Re : Dewhurst Part number – 002099-400011 CJ40 24V EN BUZZ

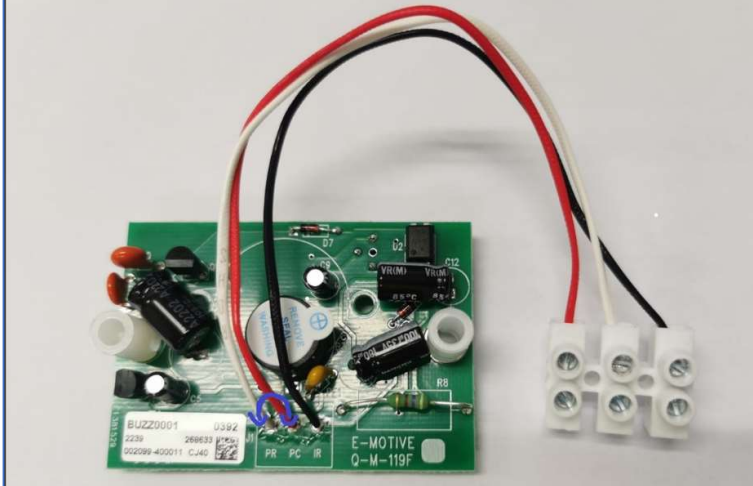
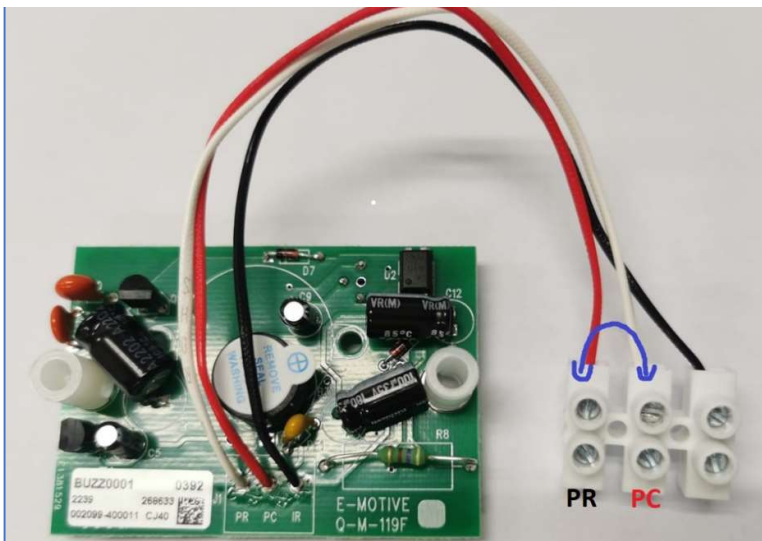
It was just brought to my attention that the wires shipped in the latest batch of EN Buzz's have the **Red and White wires swapped on the PCB solder terminals PC and PR** . This means that the Buzzer **would not work**. Please see the photo below .

Immediate suggested **CORRECTIVE ACTION**– swap RED and WHITE wires at the connector end as shown below, i.e. White to PR and Red to PC. The buzzer will then work.
